DESCRIPTION AND SAFETY ANALYSIS
OF PROPOSED CHANGE NPF-10/15-224 (REV. 4)

This is a request to revise Technical Specification 3/4.7.1.5, "Main Steam Line Isolation Valves," and Technical Specification 3/4.7.1.2, "Auxiliary Feedwater System."

DESCRIPTION AND SAFETY ANALYSIS
OF PROPOSED CHANGE NPF-10/15-231

This is a request to revise Technical Specification 3/4.1.3.6. "Regulating CEA Insertion Limits."

FIGURE 3.1-2

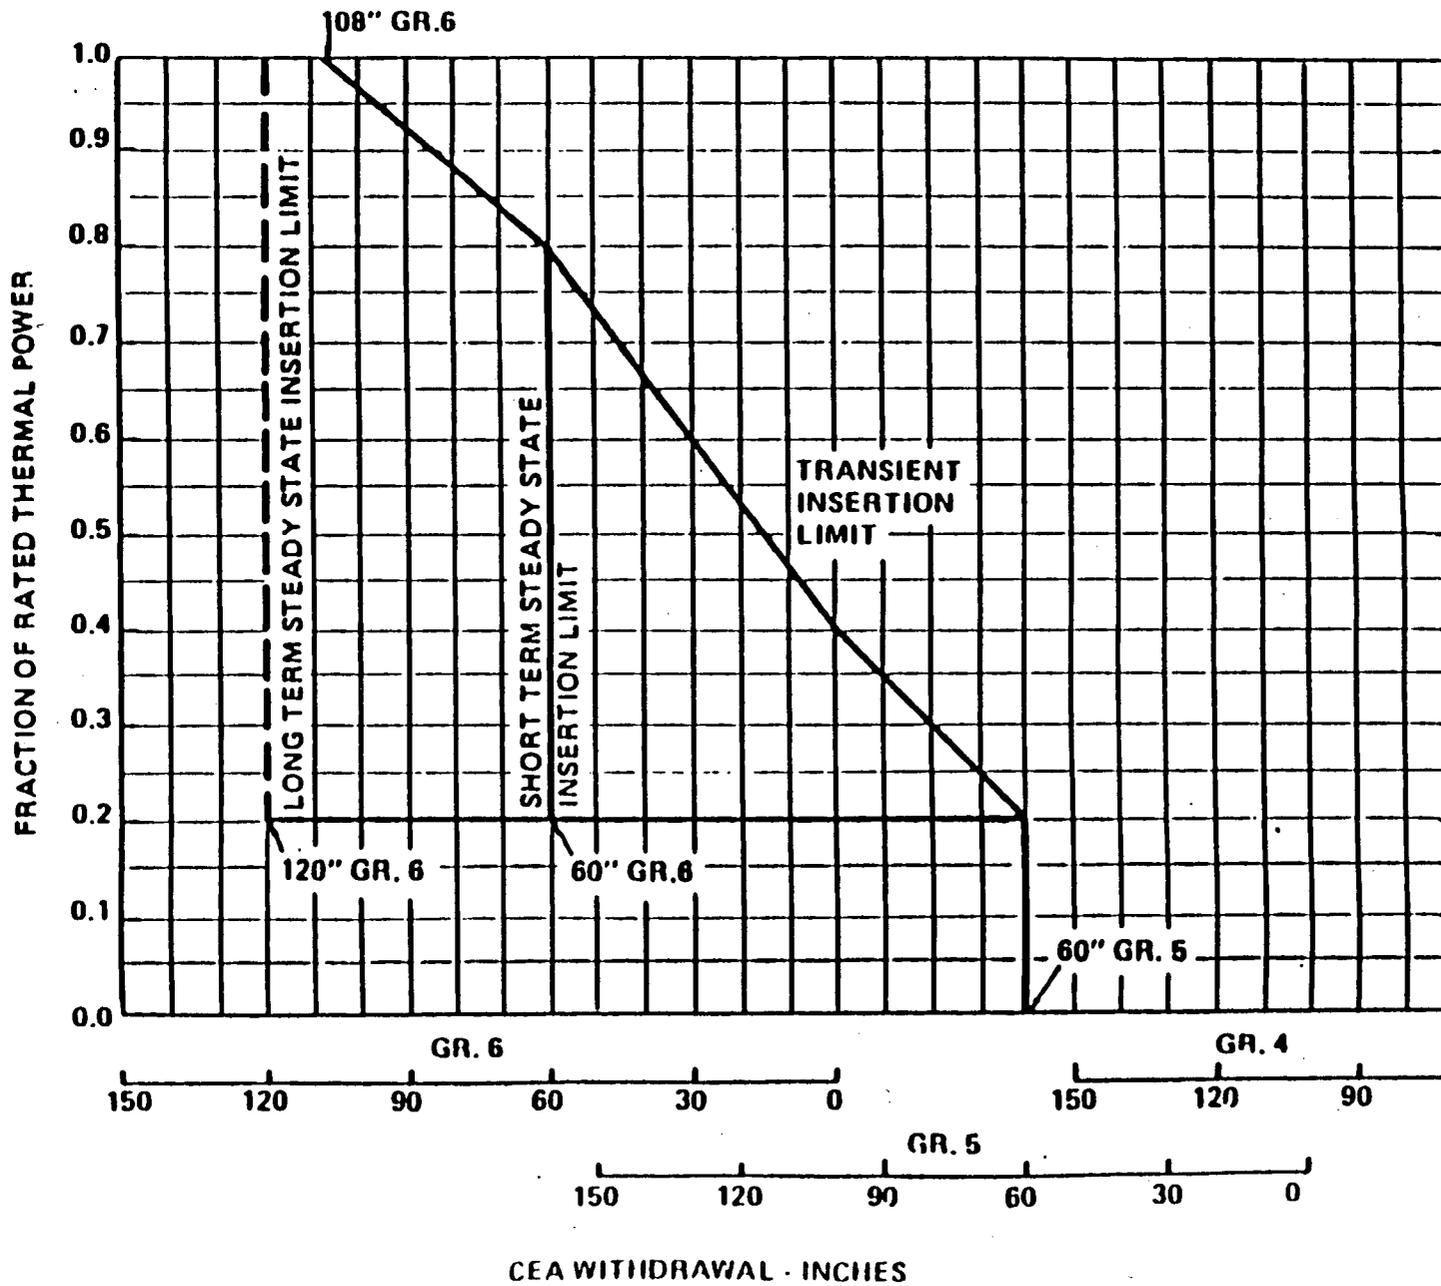
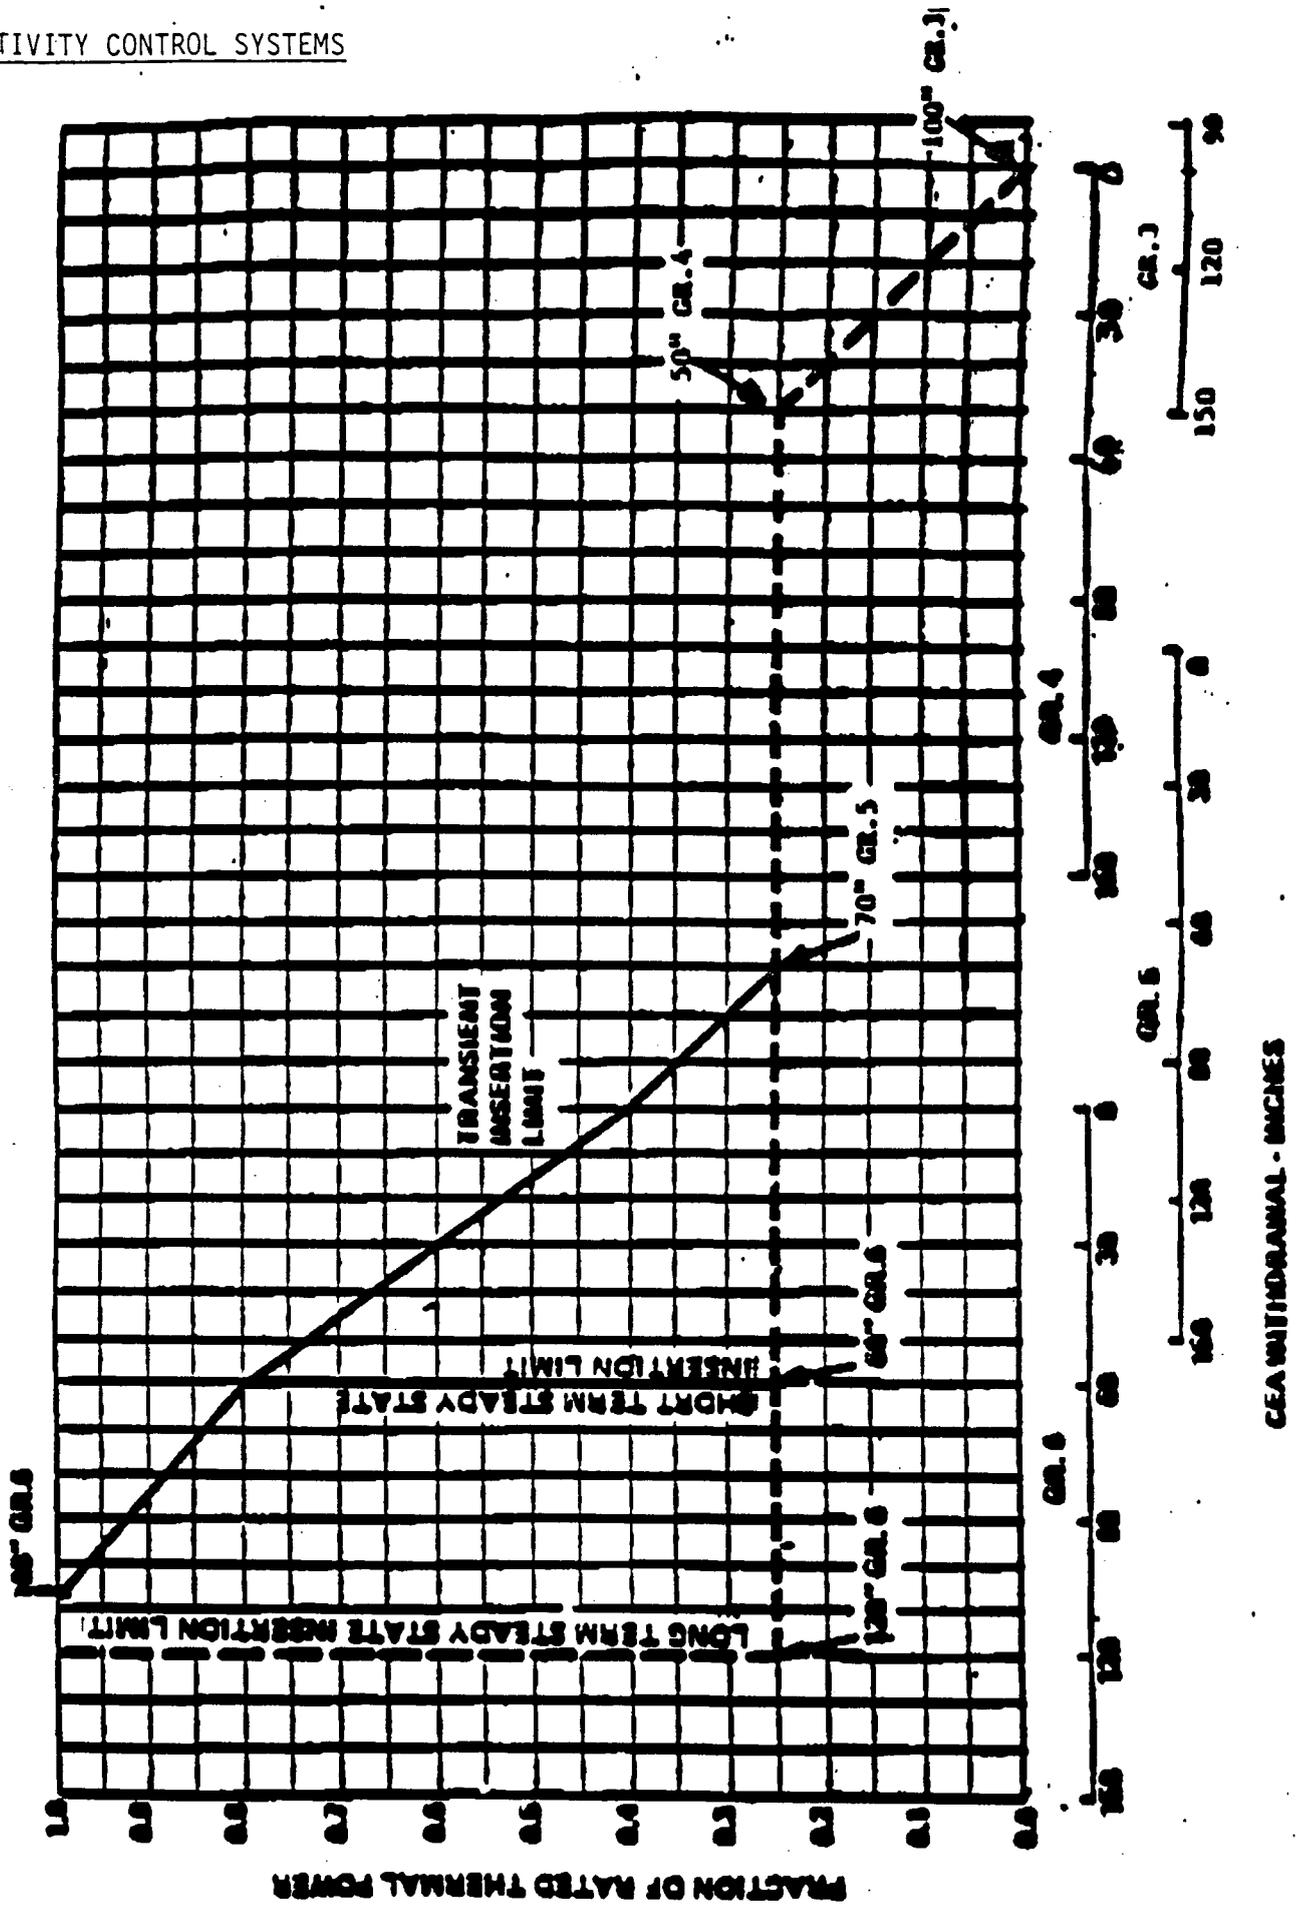
The proposed change revises Figure 3.1-2 of Technical Specification 3/4.1.3.6, "Regulating CEA Insertion Limits." The existing Technical Specification Figure 3.1-2 provides the CEA withdrawal sequence and insertion limits when the Core Operating Limit Supervisory System (COLSS) is in or out of service. The figure also delineates the Short Term and Long Term Steady State Insertion Limits.

The revised Technical Specification figure relaxes the CEA insertion limits at low power levels (at or below 25% power). Relaxation of the Power Dependent CEA Insertion Limits (PDIL) at low power levels will increase flexibility in the determination of Estimated Critical Position (ECP) during plant approach to criticality and will also help reduce the amount of waste water generated during a plant start up. With the current limits, boration may be required before a start up in order to assure that the ECP is within the zero power CEA insertion limits. Less restrictive CEA insertion limits will preclude the need to borate prior to startup thus reducing the volume of waste water.

The revised PDIL results in a higher maximum reactivity insertion rate (1.7×10^{-4} vs. 1.1×10^{-4} delta rho/sec) during a CEA withdrawal event at low power than previously reported. Previous analysis of this event (Cycle 3 RAR) found that an intermediate insertion rate resulted in the most adverse results. A check case determined that this remains true. Thus, the previous analysis results were demonstrated to remain bounding.

FIGURE 3.1-2

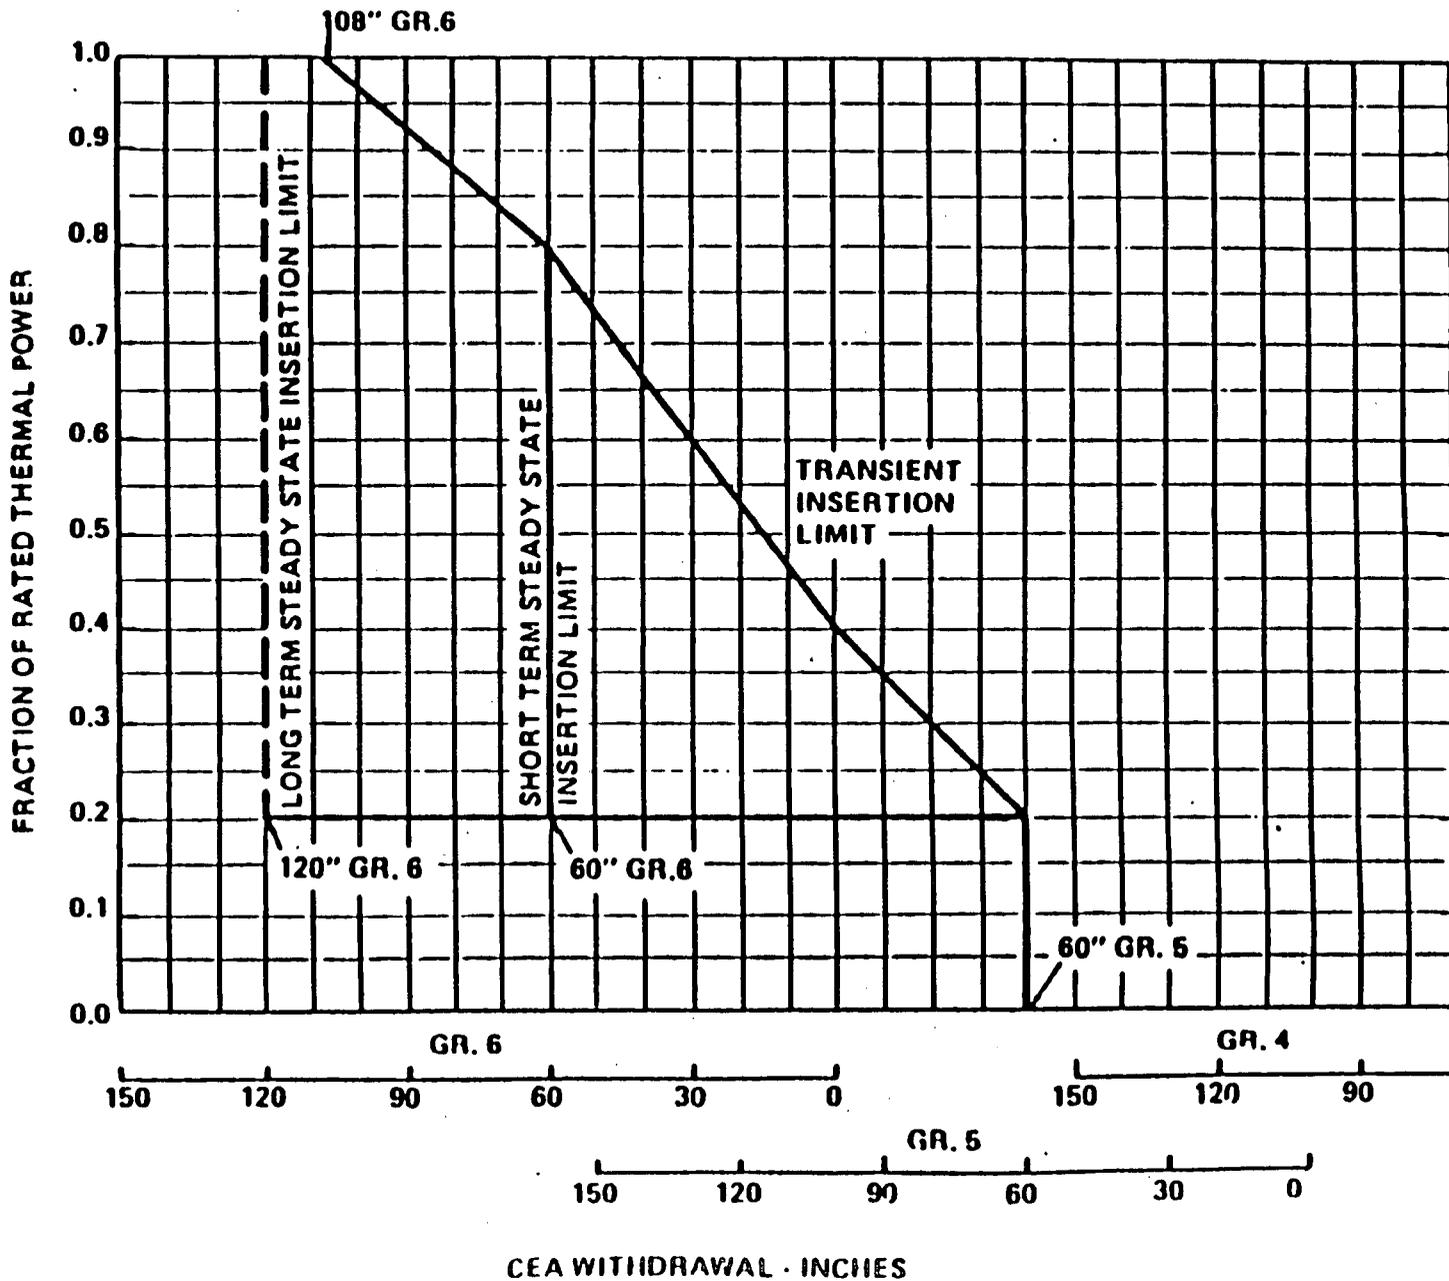
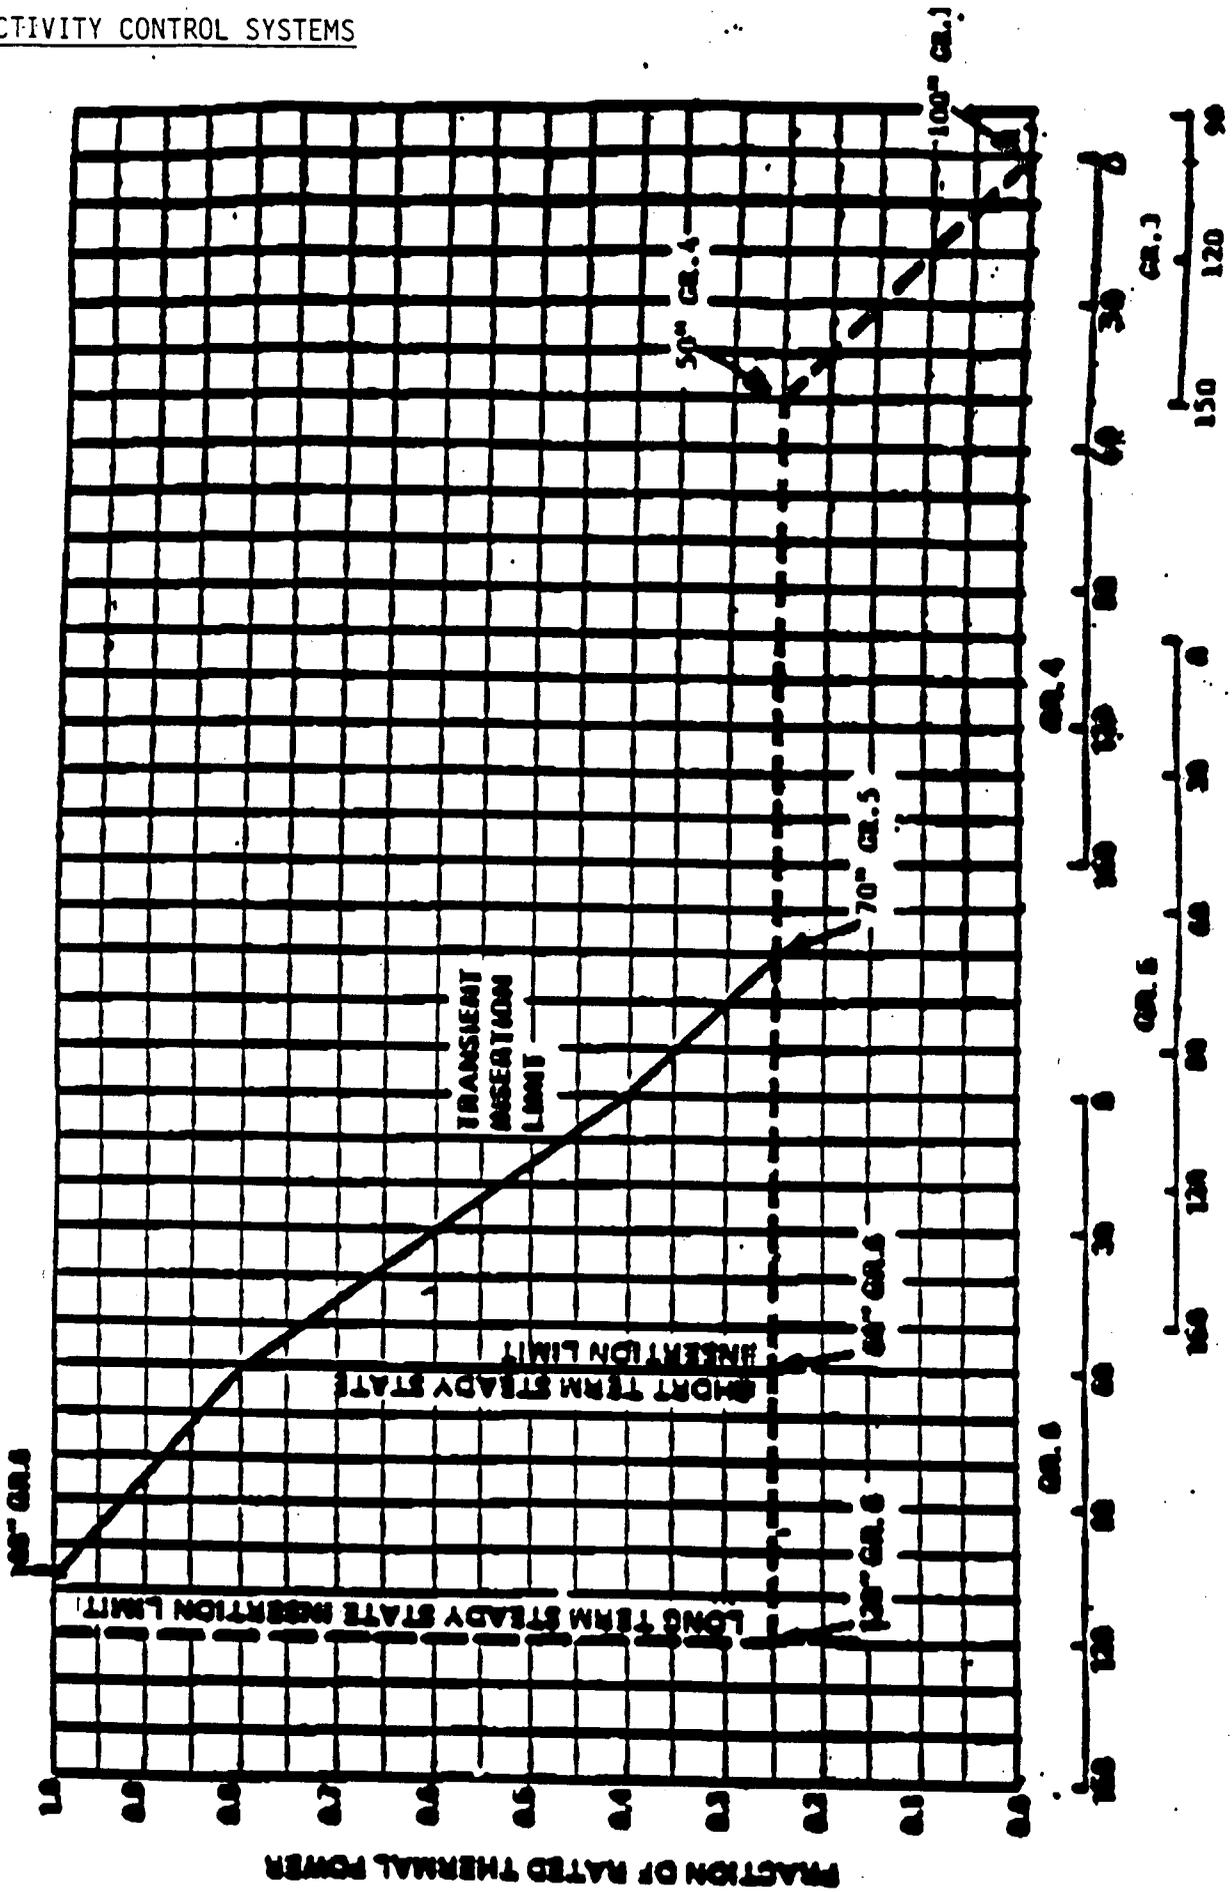
The proposed change revises Figure 3.1-2 of Technical Specification 3/4.1.3.6, "Regulating CEA Insertion Limits." The existing Technical Specification Figure 3.1-2 provides the CEA withdrawal sequence and insertion limits when the Core Operating Limit Supervisory System (COLSS) is in or out of service. The figure also delineates the Short Term and Long Term Steady State Insertion Limits.

The revised Technical Specification figure relaxes the CEA insertion limits at low power levels (at or below 25% power). Relaxation of the Power Dependent CEA Insertion Limits (PDIL) at low power levels will increase flexibility in the determination of Estimated Critical Position (ECP) during plant approach to criticality and will also help reduce the amount of waste water generated during a plant start up. With the current limits, boration may be required before a start up in order to assure that the ECP is within the zero power CEA insertion limits. Less restrictive CEA insertion limits will preclude the need to borate prior to startup thus reducing the volume of waste water.

The revised PDIL results in a higher maximum reactivity insertion rate (1.7×10^{-4} vs. 1.1×10^{-4} delta rho/sec) during a CEA withdrawal event at low power than previously reported. Previous analysis of this event (Cycle 3 RAR) found that an intermediate insertion rate resulted in the most adverse results. A check case determined that this remains true. Thus, the previous analysis results were demonstrated to remain bounding.
